P802.3ck D1.0

Comment Resolution Agenda

IEEE P802.3ck Task Force
January 2020

KR: 163 (Phil)

D1.1 Spec:

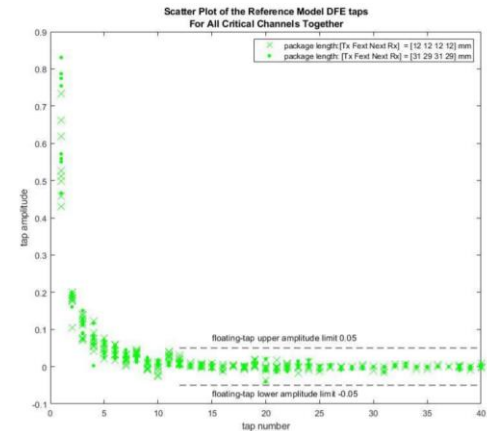
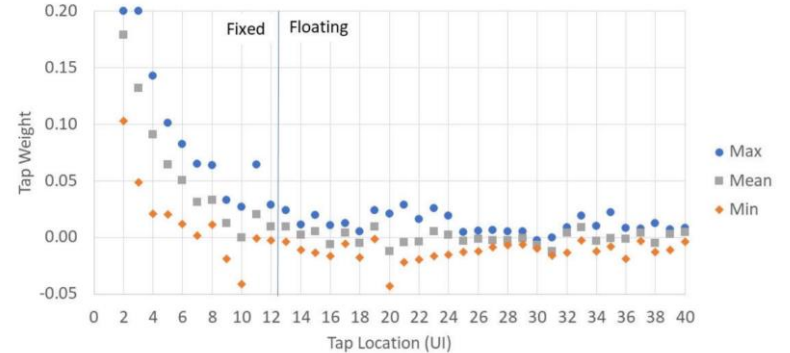
Slide 6 of heck_3ck_01_0919 shows that the DFE taps are 2 and 3 are always strongly positive, and no taps strongly negative, yet the draft would allow such untypical/hypothetical channels that a real receiver need not, and maybe can't, cope with. kasapi_3ck_01_1119 slide 7 shows the first tap also. We need sensible minimum tap limits.

Add minimum tap weight limits:

Tap 1: min +0.3

Tap 2: min +0.05

All other taps: min -0.04 (looser than for CR).

Turn the existing "Normalized DFE coefficient magnitude limit"s into "Normalized DFE coefficient limit"s.

PROPOSED REJECT.

The comment does provide sufficient evidence that the suggested remedy will not hinder reasonable, practical channels.

b(1) : change [-0.85, 0.85] to [0.3, 0.85]

b(2): change [-0.3 0.3] to [0.05, 0.3]

b(3,...,Nb): change [-0.2 0.2] -> [-0.04, 0.2]
